VIRGINIA ELECTRIC AND POWER COMPANY
RICHMOND, VIRGINIA 23261

January 31, 2006

Serial No. 06-014
NL&OS/PRW R0
Docket Nos. 50-280/281
License Nos. DPR-32/37

VIRGINIA ELECTRIC AND POWER COMPANY
SURRY POWER STATION UNITS 1 AND 2
PROPOSED TECHNICAL SPECIFICATION CHANGE AND
SUPPORTING SAFETY ANALYSES REVISIONS TO ADDRESS
GENERIC SAFETY ISSUE 191

Figure 2.1-1: Surry RWST Level Low ESF Initiation

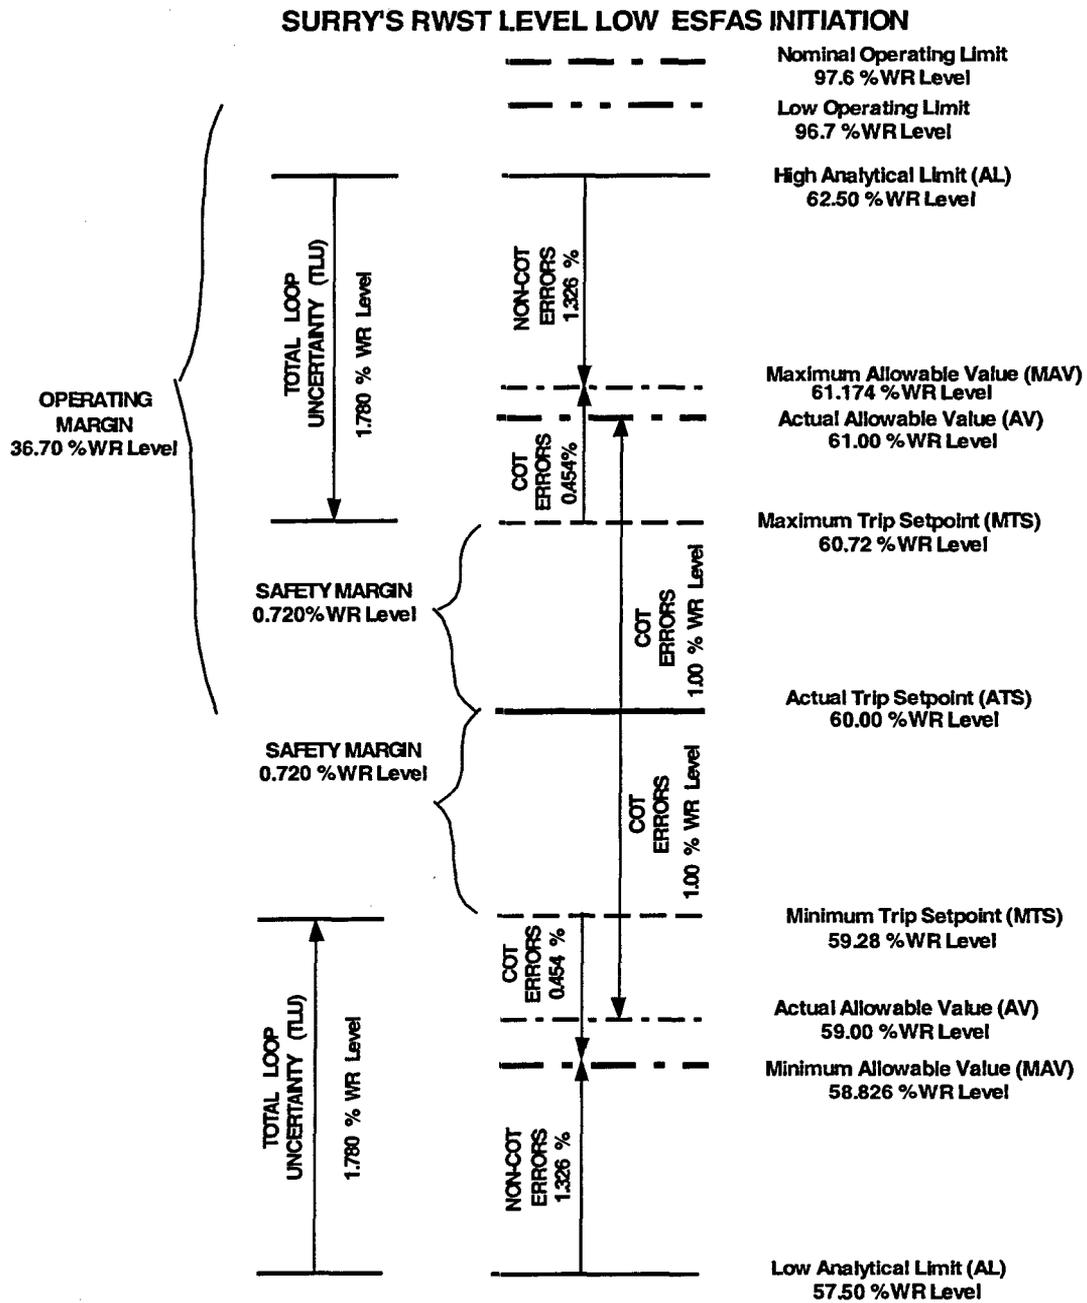
TS Setting Limit Values for the Surry RWST Level Low initiation can use the requirements of Methods 1 or 2 in ISA-RP67.04.02-2000 [20]. The determination of TS Setting Limit Values used Method 1. There are two Analytical Limits and thus two Setting Limits associated with this new function. The Analytical Limits are ≥ 57.50 % WR Level and ≤ 62.50 % WR Level. The corresponding TS Setting Limits are ≥ 59.00 % WR Level and ≤ 61.00 % WR Level from the following analysis. The reader is referred to Figure 2.1-1 for the relationship between the Analytical Limits and the TS Setting Limits.

The statistical combination of the COT and Non-COT error components is provided below and used in Figure 2.1-1 to determine the Minimum/Maximum Trip Setpoints and the Minimum/Maximum Allowable Values.

**Figure 3.10-1: Containment Air Partial Pressure versus Service Water Temperature
(Proposed TS Figure 3.8-1)**

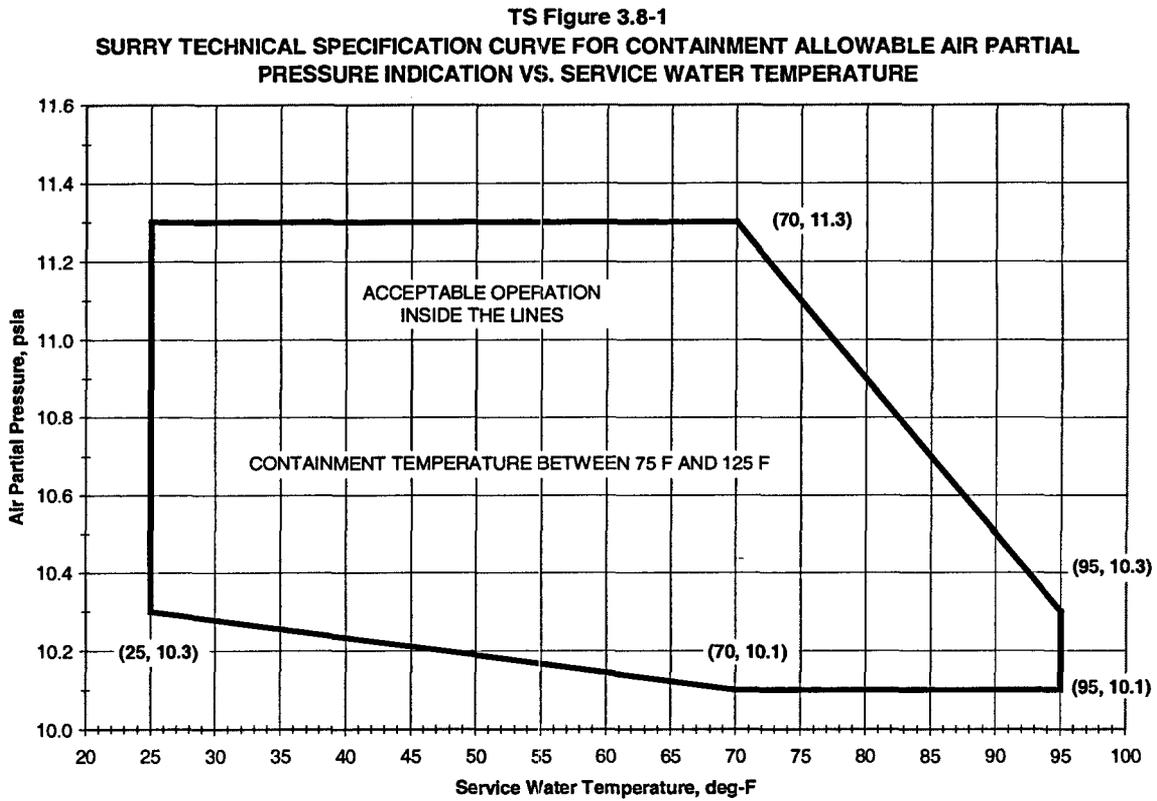
The GOTHIC containment analyses for LOCA containment peak pressure (Section 3.2), MSLB containment peak pressure (Section 3.7), and LOCA containment depressurization (Section 3.4) support an increase in the containment air partial pressure upper limit in TS Figure 3.8-1 from 10.3 psia to 11.3 psia. As a result, the TS lower limit will be increased above 9.0 psia to recover LHSI pump NPSH margin that has been reduced by the delayed RS pump start. The proposed TS lower limit linearly decreases from 10.3 psia at 25 F SW to 10.1 psia at 70 F SW then remains constant at 10.1 psia to 95 F SW. Operating margin has also been increased at high SW temperature (from 0.1 psi to 0.2 psi margin at 95 F). The proposed change to TS Figure 3.8-1 and the technical basis for the upper and lower limits are presented in Section 3.10 of this report.

Changes to the TS 3.8 Basis are required to reflect the technical basis for the revised TS Figure 3.8-1. The MSLB peak pressure analysis sets the horizontal upper limit line. The plant changes no longer support a “subatmospheric peak pressure” since some GOTHIC cases produce long-term pressures that exceed 0.0 psig. Therefore, it is proposed to change the description from “subatmospheric peak pressure” to “LOCA depressurization criteria” to reflect the positive pressure after one hour. Also, the minimum air partial pressure is being changed from a constant 9.0 psia to a variable line in order to recover NPSH margin at low SW temperatures. The TS Basis will be revised to reflect the variable lower limit in TS Figure 3.8-1.

Sections 3.3 through 3.7 describe GOTHIC containment analyses that support an increase to the TS operating domain for containment air partial pressure. This increase is possible because of the margin gain in accident peak pressure from using GOTHIC instead of LOCTIC. A proposed change to Surry TS Figure 3.8-1 is provided as Figure 3.10-1. This operating domain maintains the current limits of 25-95 F for SW temperature and 75-125 F for containment air temperature. Allowable limits for containment air partial pressure are defined by the following restrictions:

- The LHSI pump NPSH analyses set the lower limit on air partial pressure (the RS pumps use the same assumptions but have more NPSH margin). At the same air partial pressure, the NPSH analyses are limiting at 25 F SW. Therefore, the TS lower limit is sloped below 70 F to recover LHSI pump NPSH margin. The proposed lower limit in Figure 3.10-1 ensures at least 1.6 ft of NPSH margin across the entire SW temperature range.

TS FIGURE 3.8-1

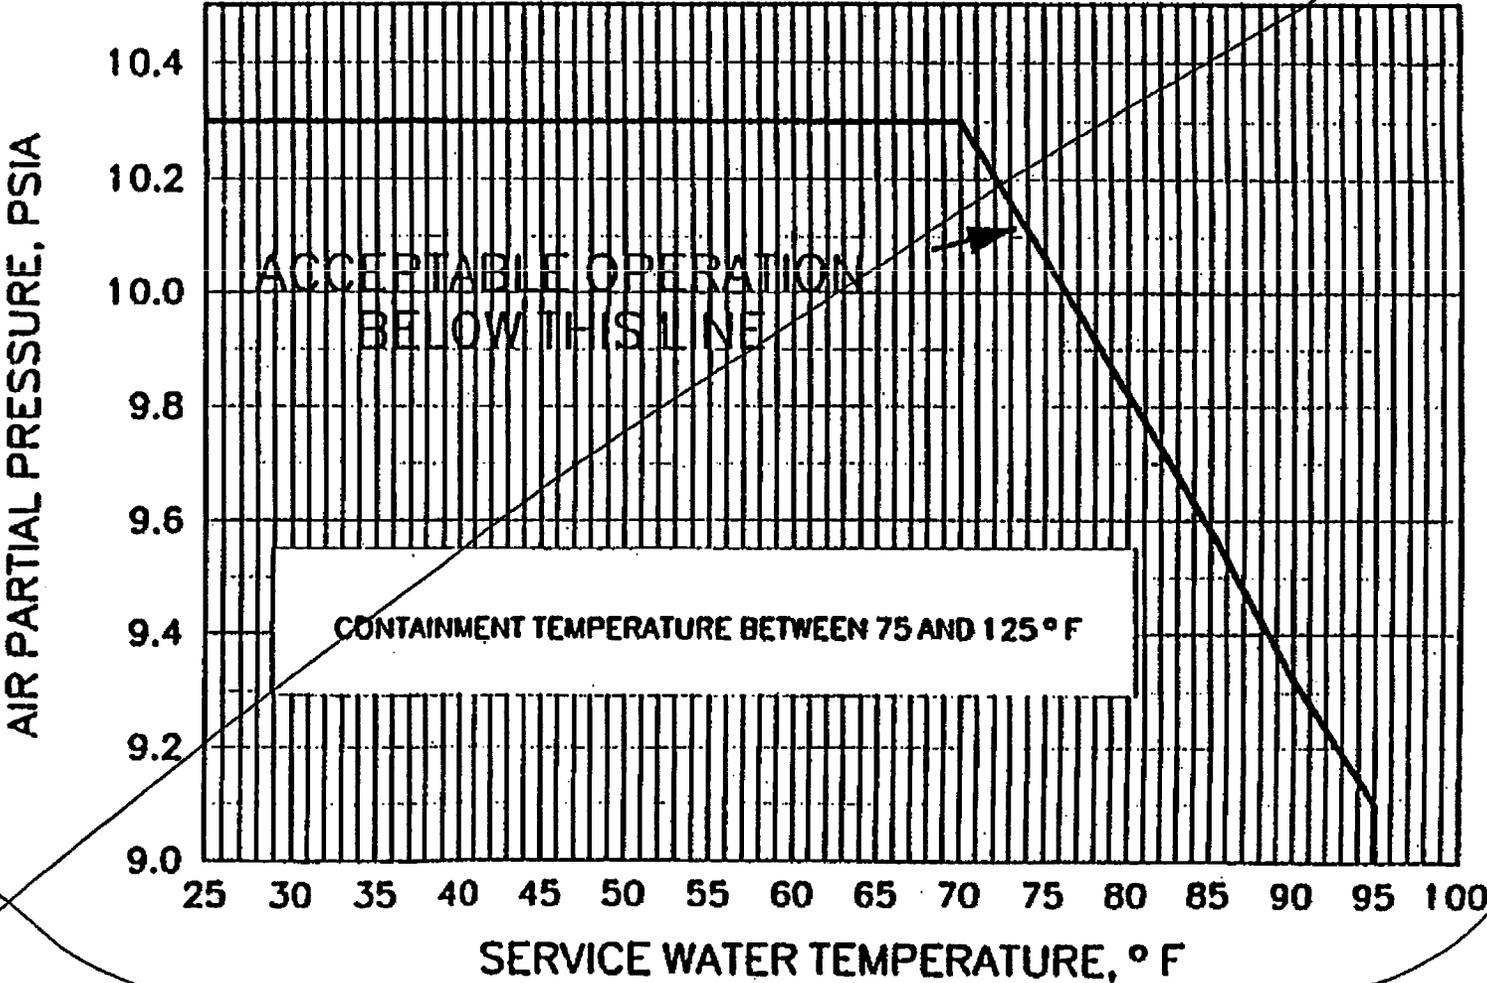
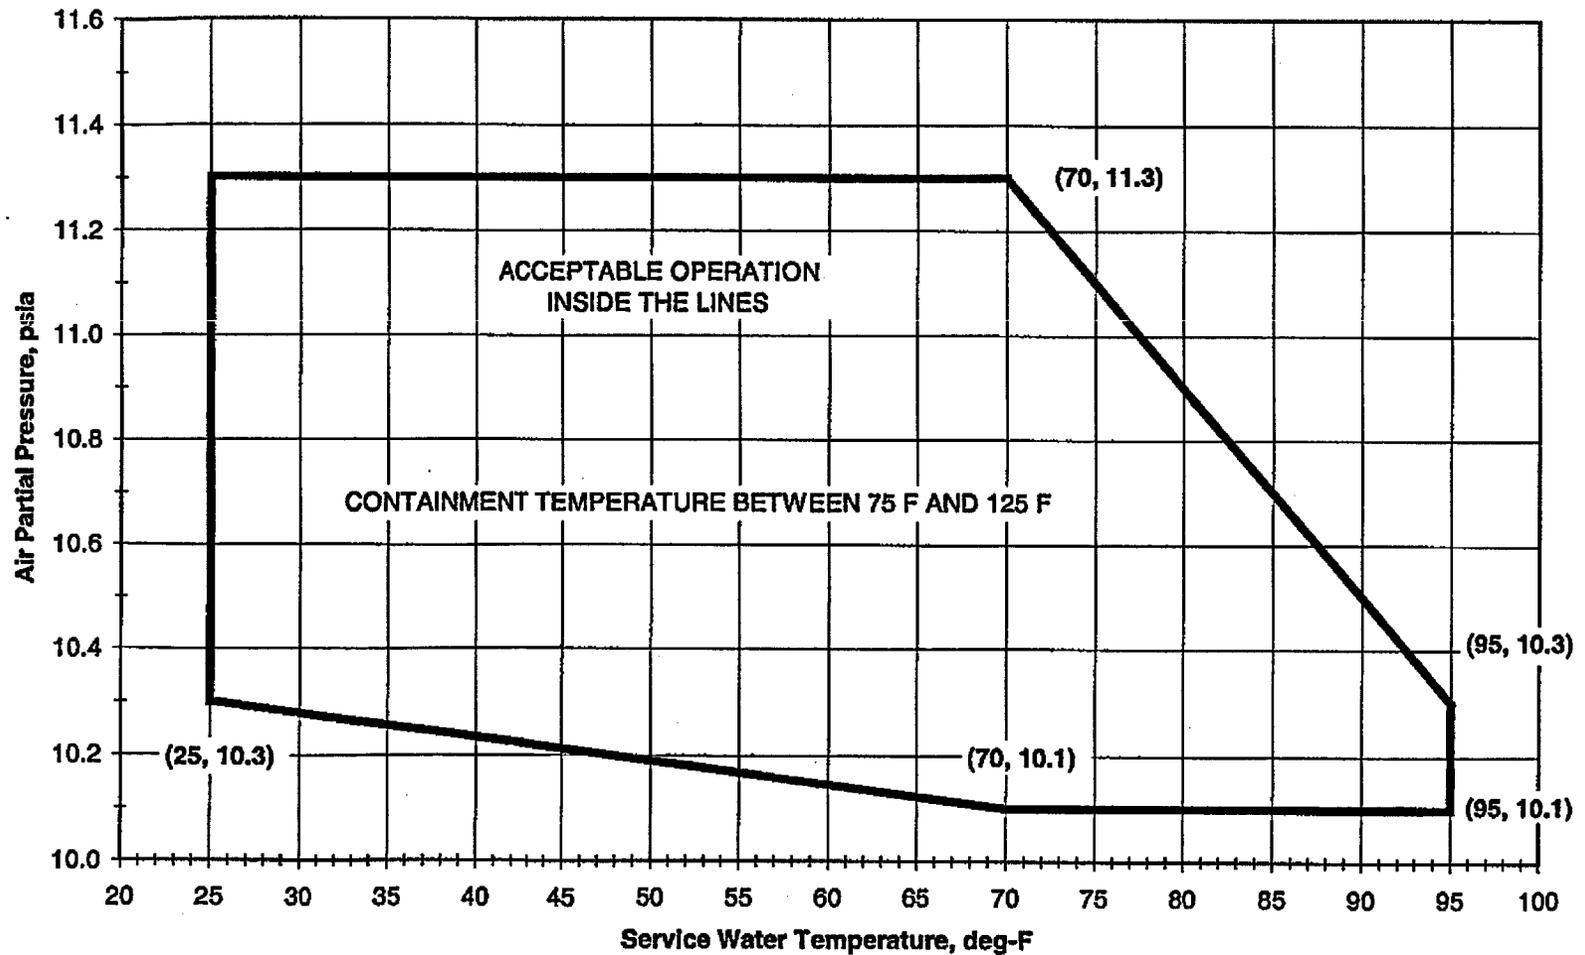
The horizontal ^{UPPER} limit line in TS Figure 3.8-1 is based on ^{MSLB} ~~LOCA~~ peak calculated ^{DEPRESSURIZATION} pressure criteria, and the sloped line is based on LOCA ~~subatmospheric peak~~ ^{pressure} criteria. FROM 70°F TO 95°F SERVICE WATER TEMPERATURES.

If the containment air partial pressure cannot be maintained greater than or equal to ~~9.0~~^{THE MINIMUM PRESSURE IN FIGURE 3.8-1} psia, the reactor shall be brought to the HOT SHUTDOWN condition. The shell and dome plate liner of the containment are capable of withstanding an internal pressure as low as 3 psia, and the bottom mat liner is capable of withstanding an internal pressure as low as 8 psia.

INSERT #4 to TS 3.8: Replace Figure 3.8-1 with the below figure (Figure 3.10-1 in technical report NE- 1460

SURRY TECHNICAL SPECIFICATION CURVE FOR CONTAINMENT
ALLOWABLE AIR PARTIAL PRESSURE INDICATION VS. SERVICE WATER TEMPERATURE

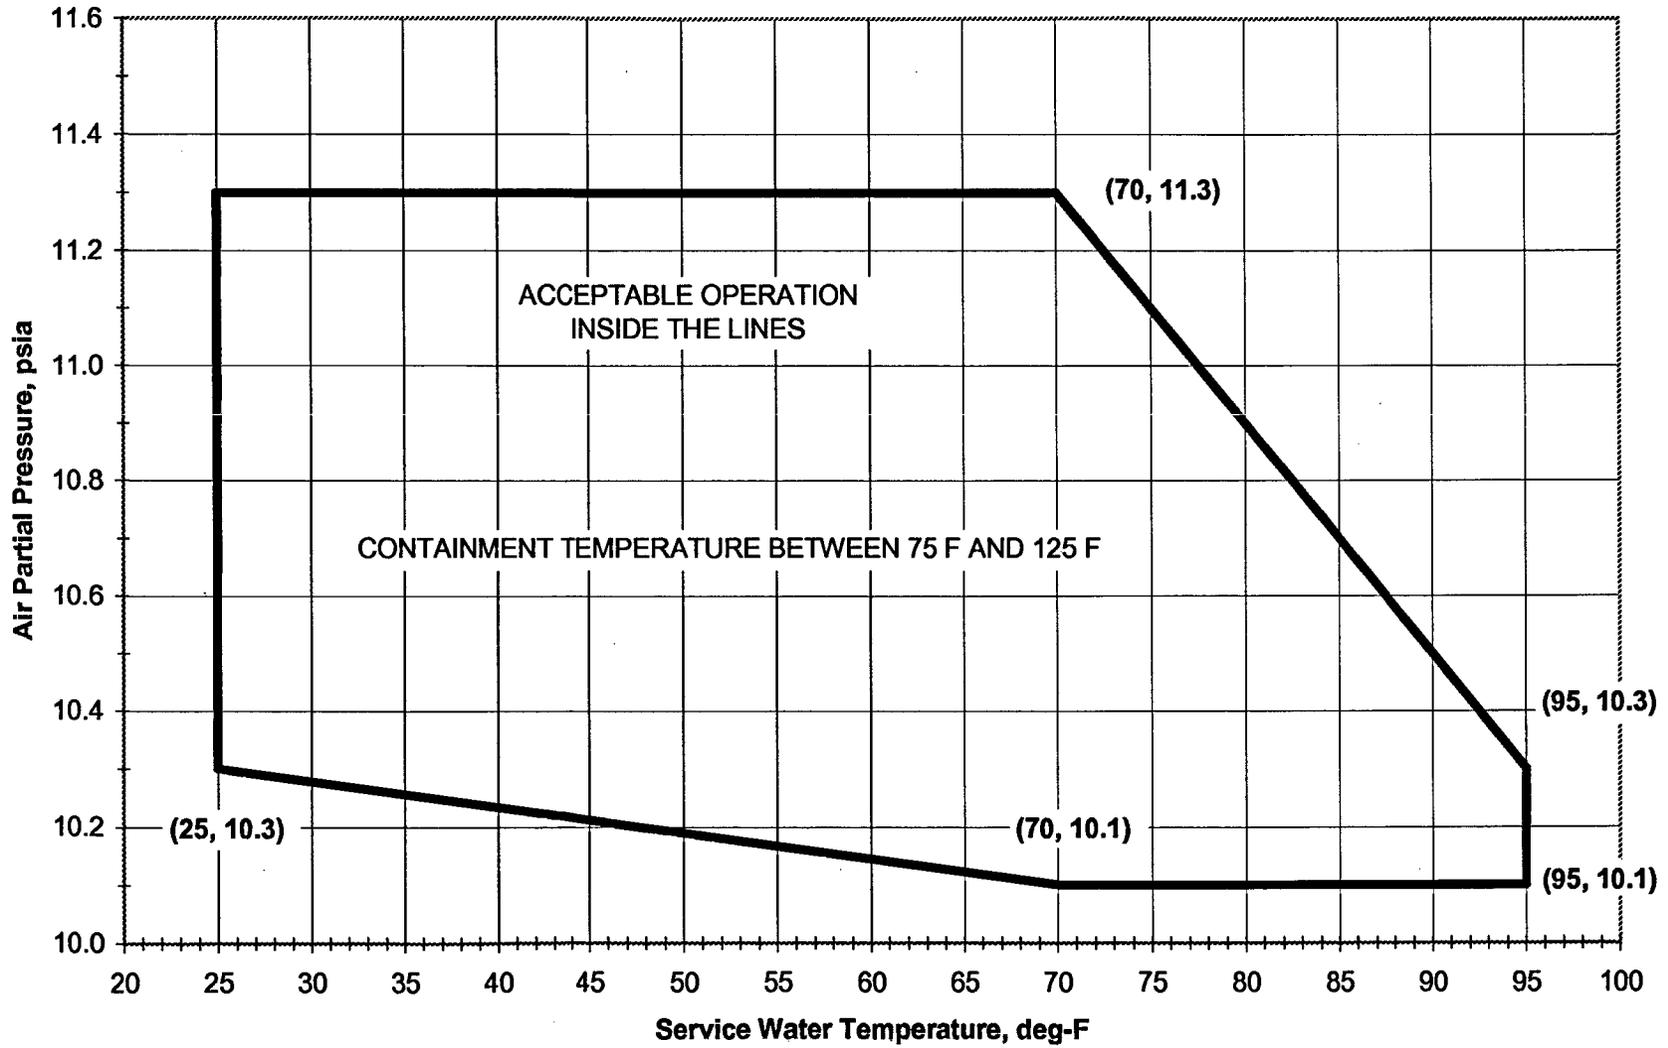
The horizontal upper limit line in TS Figure 3.8-1 is based on MSLB peak calculated pressure criteria, and the sloped line from 70°F to 95°F service water temperatures is based on LOCA depressurization criteria.

If the containment air partial pressure cannot be maintained greater than or equal to the minimum pressure in Figure 3.8-1, the reactor shall be brought to the HOT SHUTDOWN condition. The shell and dome plate liner of the containment are capable of withstanding an internal pressure as low as 3 psia, and the bottom mat liner is capable of withstanding an internal pressure as low as 8 psia.
